PR/1248/22

Record of Executive Business and Chief Executive's Order

Reg. Reference: SD22A/0330 **Application Date:** 11-Aug-2022
Submission Type: New Application **Registration Date:** 11-Aug-2022
Correspondence Name and Address: John Hodgins Amalfi, Rocky Road, Wicklow Town,
Co. Wicklow
Proposed Development: Construction of a single storey valeting building and
canopy and associated site works and services.
Location: Units 5, (Nissan) and Volkswagen Valley Motor Mall,
Dublin 22
Applicant Name: Gabriel Keane Motors Ltd
Application Type: Permission

Figure 1 Extract from Proposed Site Layout Sheet 2 of 5 from Reg. Ref. SD21A/0291.

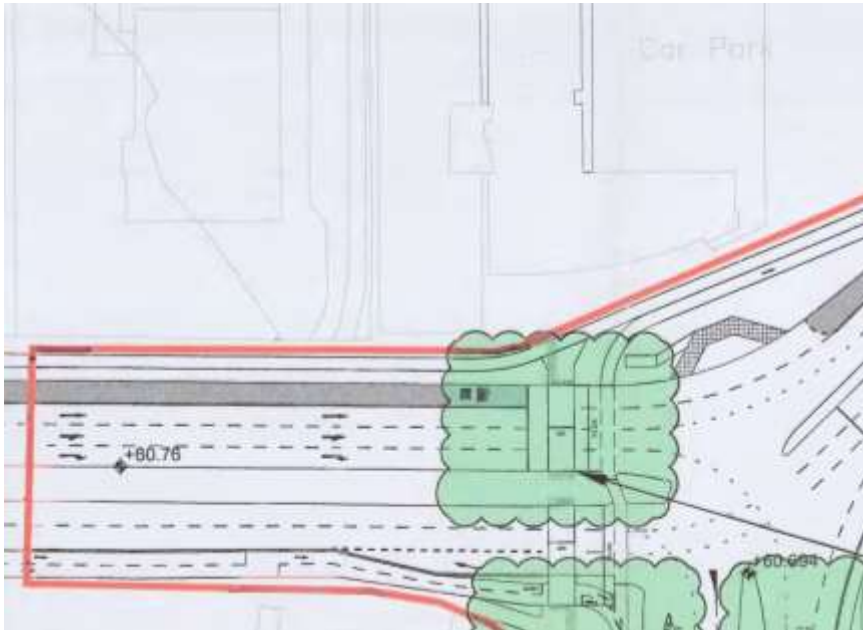
However, based on a site visit on the 14th of September 2022 it appears that a vehicular access from Fonthill Road to the subject site is being reinstated as part of these upgrade works.

The submitted site plan with the subject application also shows this southern access. Although the application documentation states that the northern access would be the site's entrance and exit. It is not clear from the application material if any changes are proposed to the southern boundary/access, which currently has a vehicle barrier gate and green palisade fencing across it.

From a further phone conversation with the Roads Department, on the 29th of September 2022, they expressed concern with reopening the southern access given that this was not provided for under the adjoining application for Fonthill Road and would cross a cycle path and a bus lane.

If the proposed development were to be granted this would restrict the use of this site as an access road again in the future. While this is not desirable in terms of connectivity of these lands, it is noted that the road is not taken in charge and the permitted Fonthill Road upgrades omit access from the south.

However, the applicant should be requested to provide additional information in relation to the historical use of the site as an access road, if known, and importantly, what is proposed in relation to the southern boundary/access. The applicant should take into account that the Fonthill Road upgrades do not permit an access to the subject site. **This should be addressed via additional information.**
